**Historic Landmark Commission
March 26, 2012
National Register Historic Districts
NRD-2012-0011
Old West Austin
3209 Glenview Avenue**

Construct a second story addition and revise other architectural features of a c.1940 house.

FRONT ELEVATION

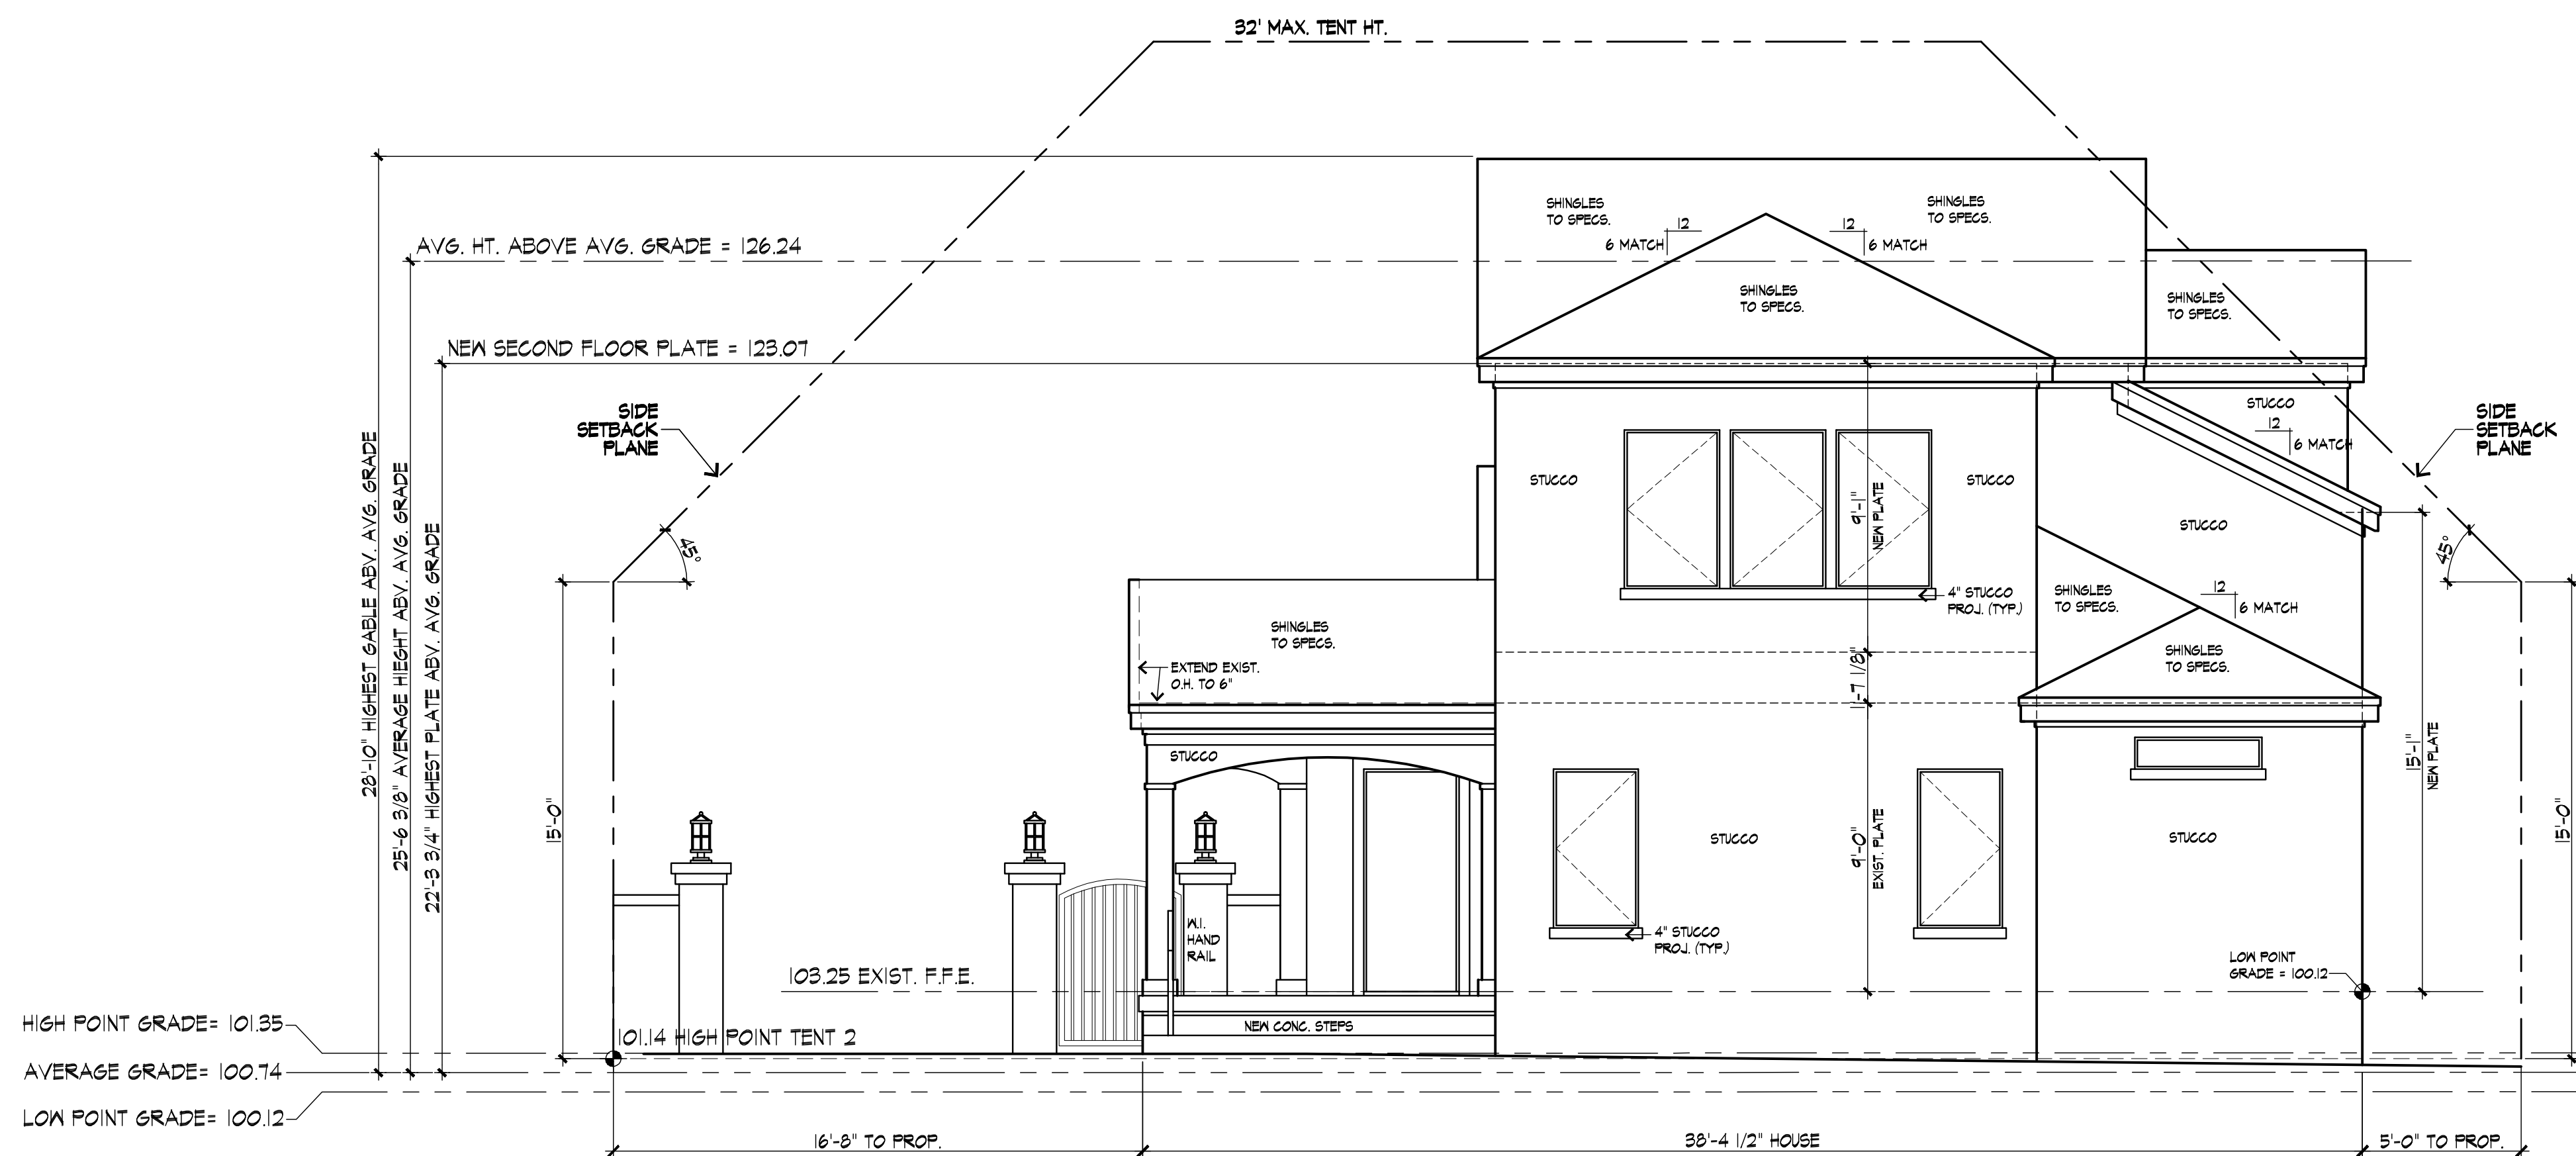
Although the enclosed plans indicate the addition of stucco on all elevations, the applicant is proposing to maintain and paint the existing brick on the first level, and use horizontal lap siding on the second story addition. The applicant further proposes to salvage and reuse as much of the existing decorative wood elements at the side porch.

Although the scale and style of the addition and façade revisions are compatible with the architectural character of the National Register District, the changes to the appearance of the house are significant enough to render the property non-contributing to the National Register District.

Staff requests that the applicant reconsider the design to maintain the property's historical integrity and status as contributing to the National Register District.

The applicant has consulted with members of the Brykerwoods Neighborhood Association and has revised his original proposal per their input. The applicant has agreed to maintain and paint the existing brick on the first level, and use horizontal lap siding on the second story addition. The applicant further agrees to keep the wood posts on the porch and to salvage and reuse as much of the existing decorative wood elements as possible. These revisions will be noted by staff on the plans when stamped set released for permit.

Staff recommends that if the applicant continues to pursue the design as proposed, that the applicant be required to prepare a City of Austin Documentation Package prior to release of the permit, consisting of a sketch of the existing site and floor plan, photographs of all four elevations, and a history of the house. Staff further recommends that the revisions to the design related to siding materials and porch elements be noted on the plans when stamped for release of permit.
